Frodsham Solar

Environmental Statement: Volume 2

Appendix 9-1: Flood Risk Assessment and Drainage Strategy Part 5 of 5

May 2025

Figure Number
Figure 2-5j

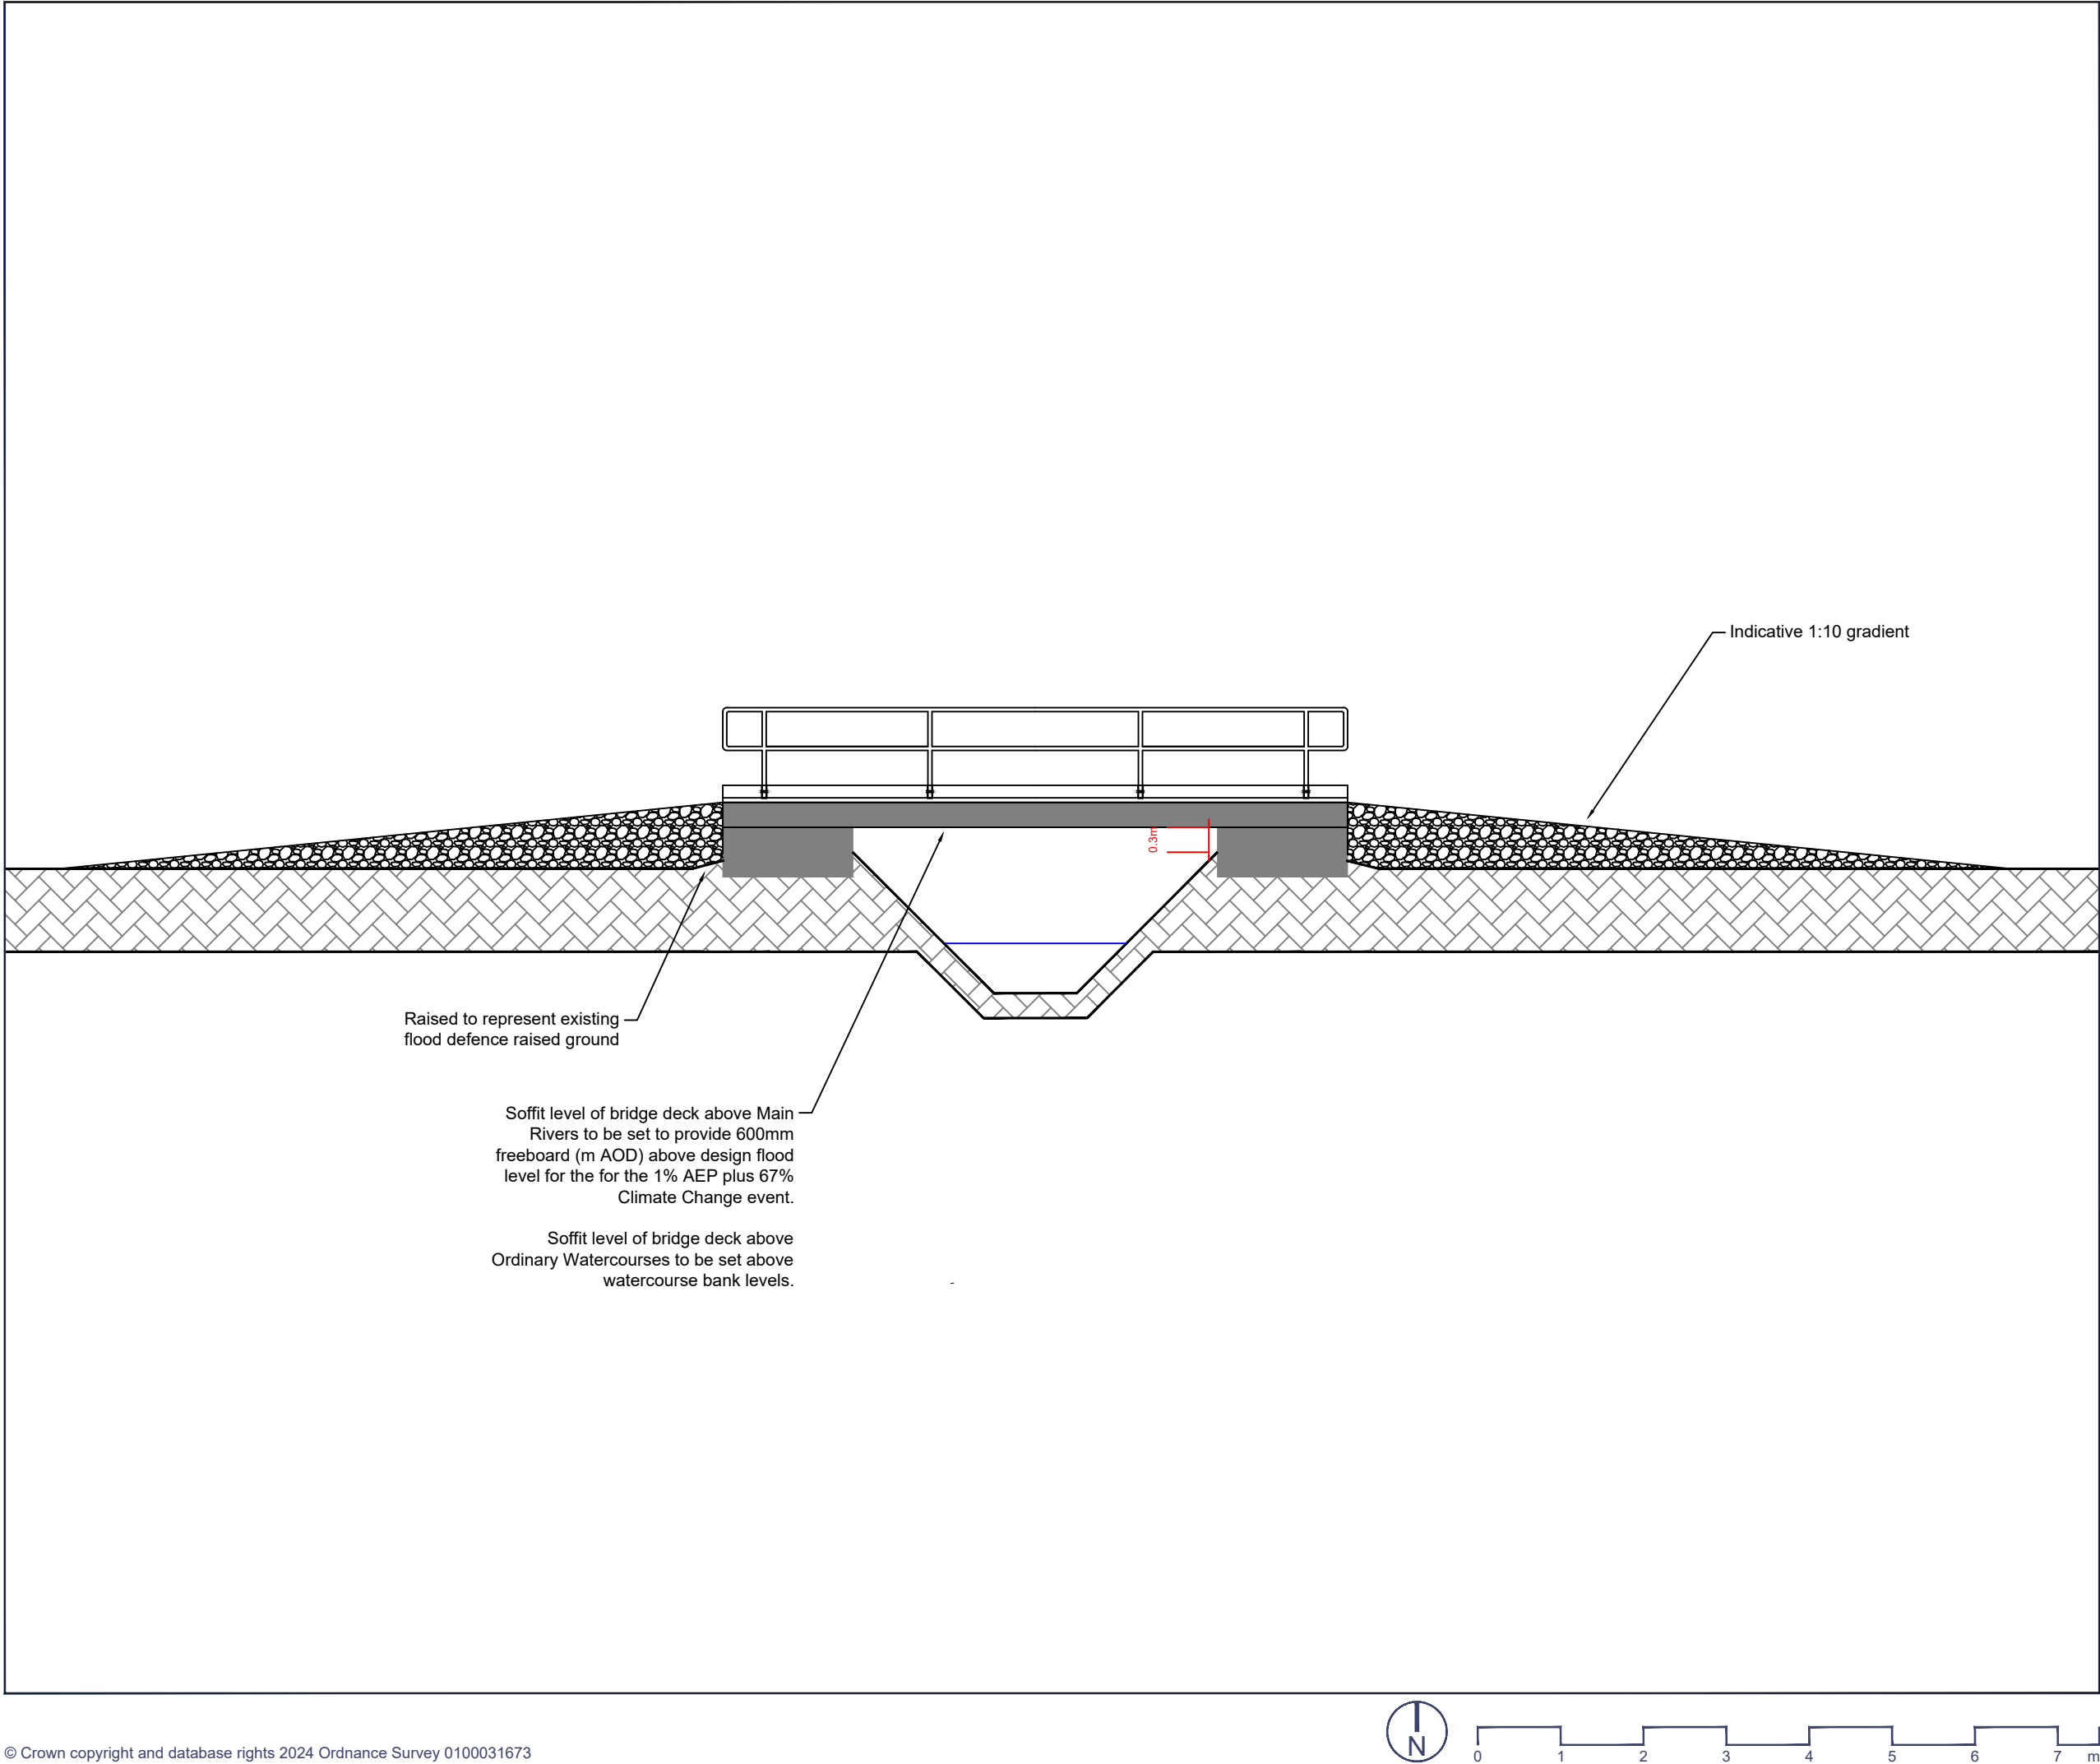
For the design and installation of new crossing points, abutments should be set back at-least 8m from the top of the bank, not embedded in the bank as is illustrated in Figure 2-5j. This approach would avoid the necessity of over-pumping to ensure a dry environment for construction (PEIR, Chapter 7; Section 7.7; paragraph 7.7.36). This would not damage the integrity of the banks and channel bed. Setback abutments would also allow the bridge deck to be constructed at a higher level, reducing areas of deep shade and allowing free mammal passage...'

The design flood level for the design of on-site watercourse bridge crossings stipulated by the EA is the River Mersey 1 in 200 (0.5%) annual probability plus climate change event. The 0.5% annual probability plus climate change (upper end scenario) flood level for the River Mersey in the location of the access crossings is 5.88m AOD. Based on EA requirements, the bridge soffit levels would need to be set at 6.48m AOD in order to account for a 600mm freeboard. A bridge soffit of 6.48m AOD is approximately 1.5m above the watercourse bank levels.

Figure Number
Figure 2-5j

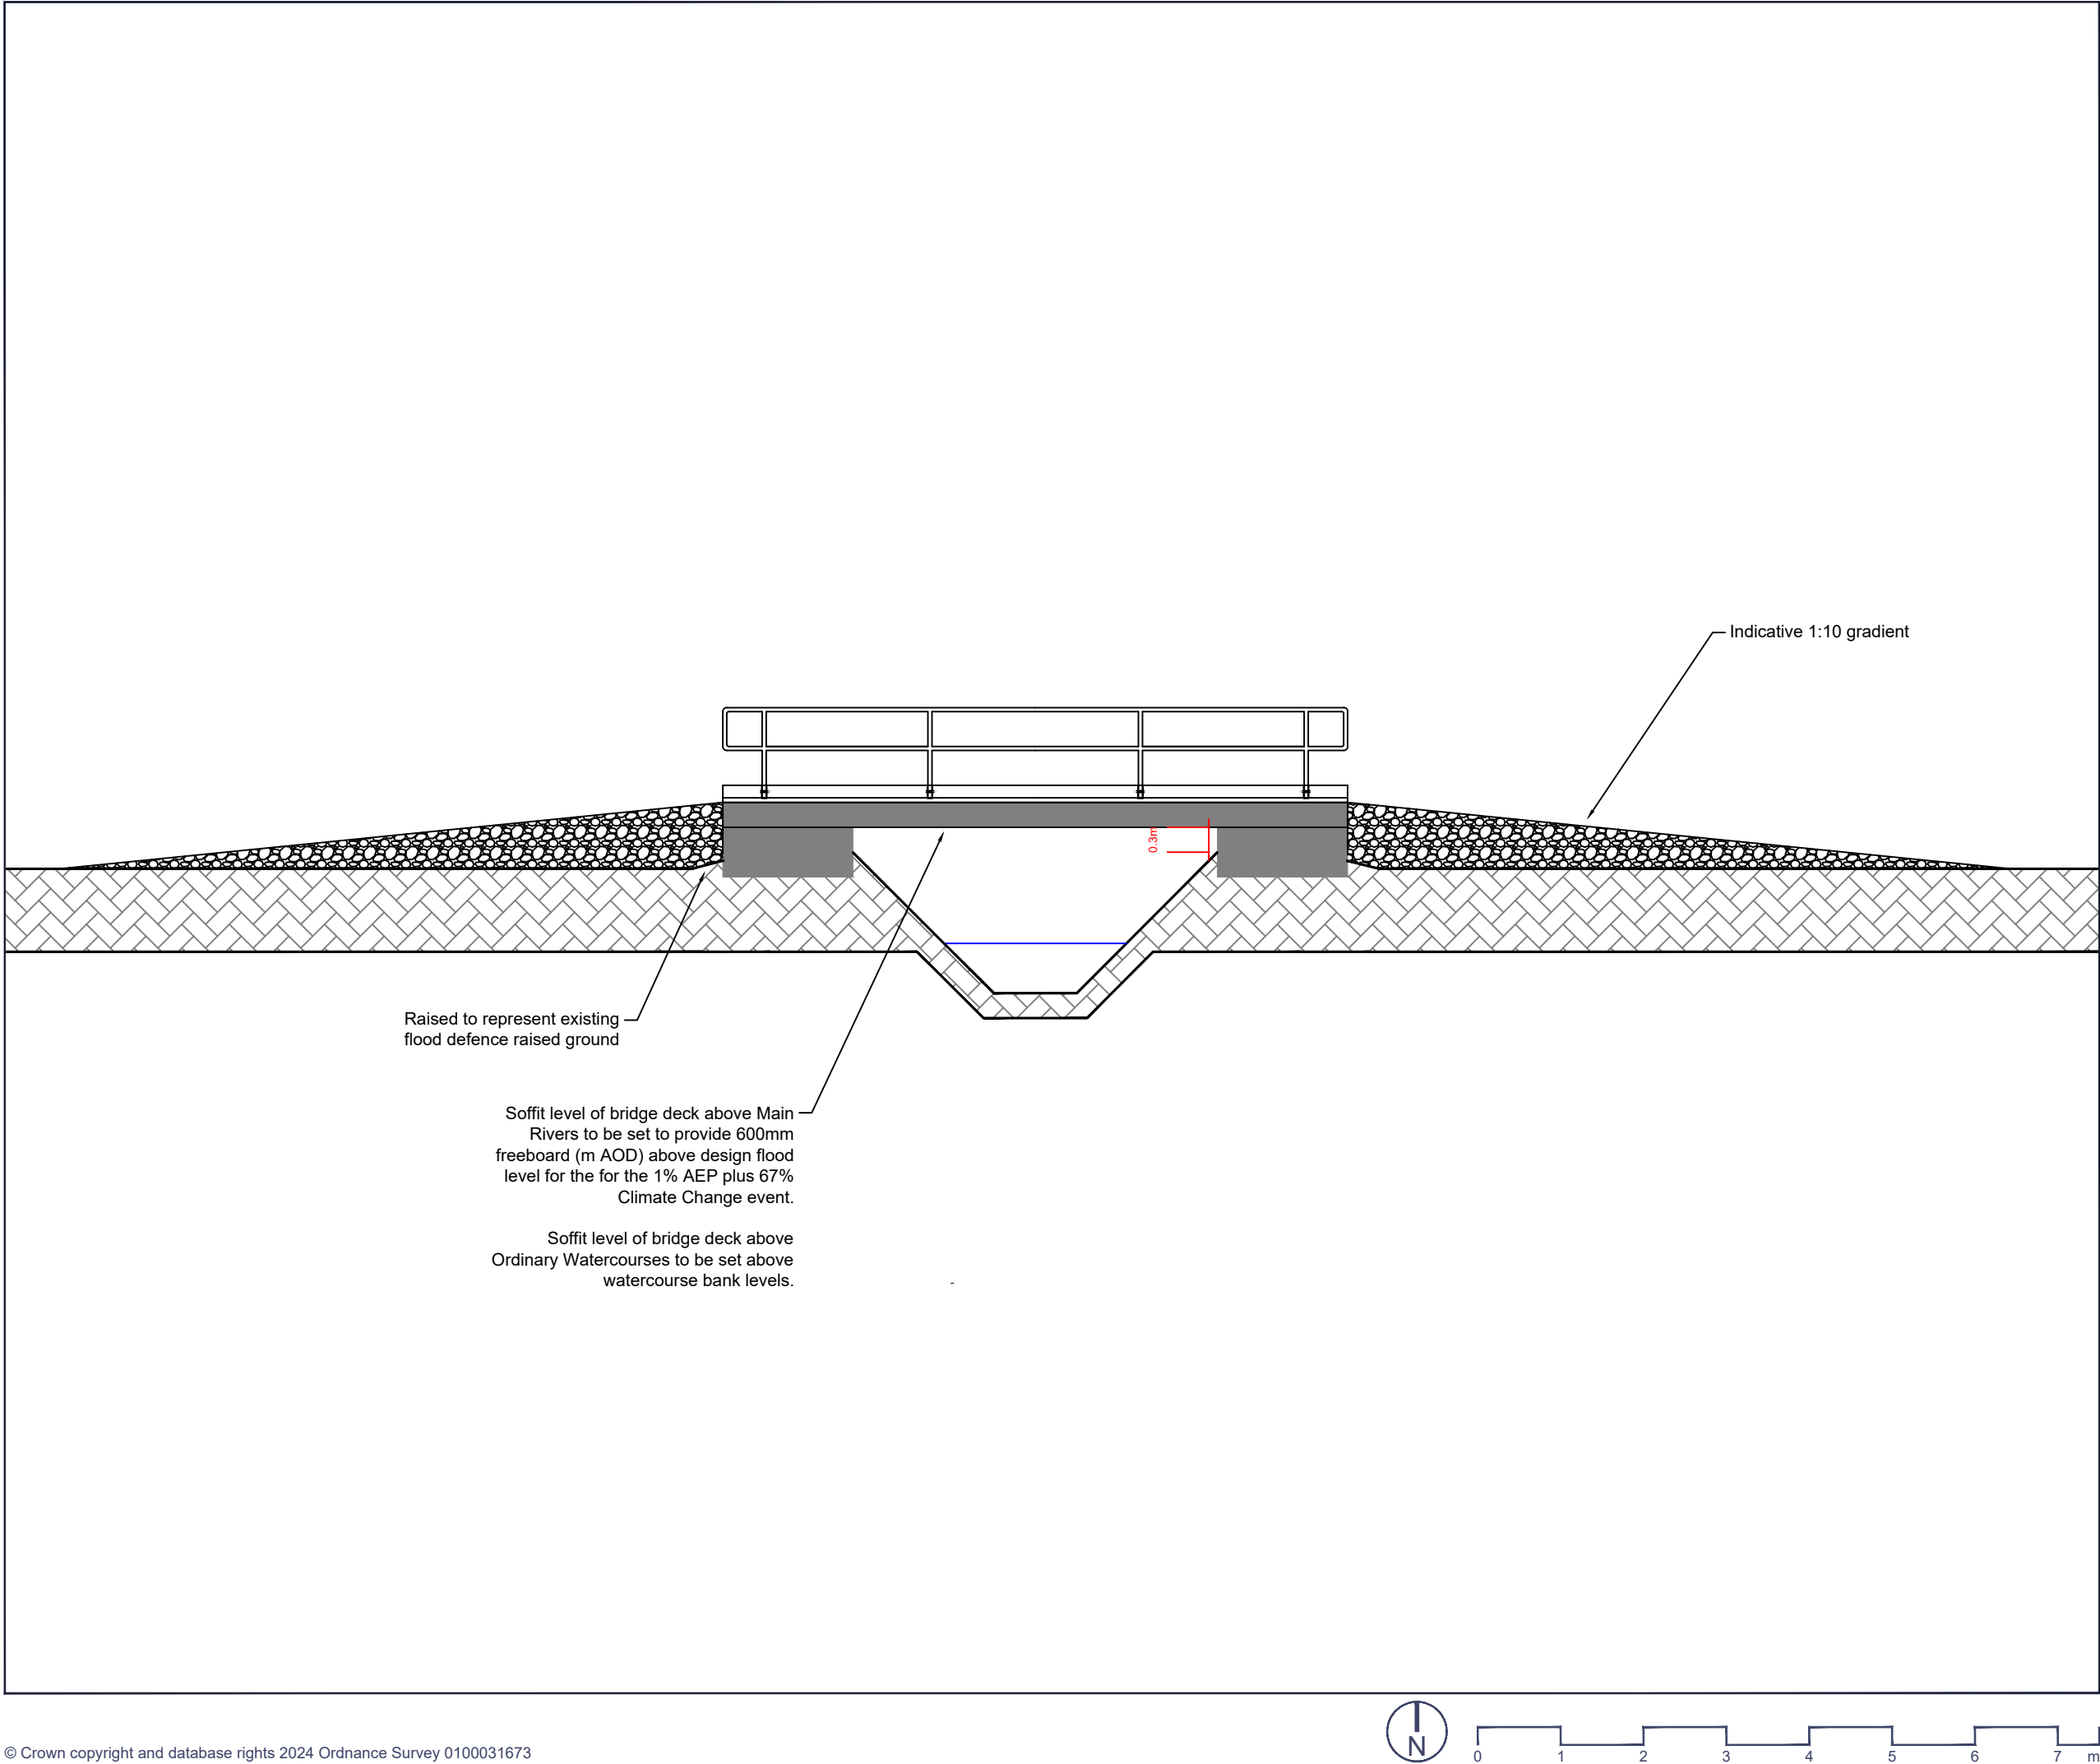
Inappropriate design and installation of new crossing points.

Damage to the integrity of embankments, channel bed and reduced mammal passage.

For the design and installation of new crossing points, abutments should be set back at-least 8m from the top of the bank, not embedded in the bank as is illustrated in Figure 2-5j. This approach would avoid the necessity of over-pumping to ensure a dry environment for construction (PEIR, Chapter 7; Section 7.7; paragraph 7.7.36). This would not damage the integrity of the banks and channel bed. Setback abutments would also allow the bridge deck to be constructed at a higher level, reducing areas of deep shade and allowing free mammal passage.
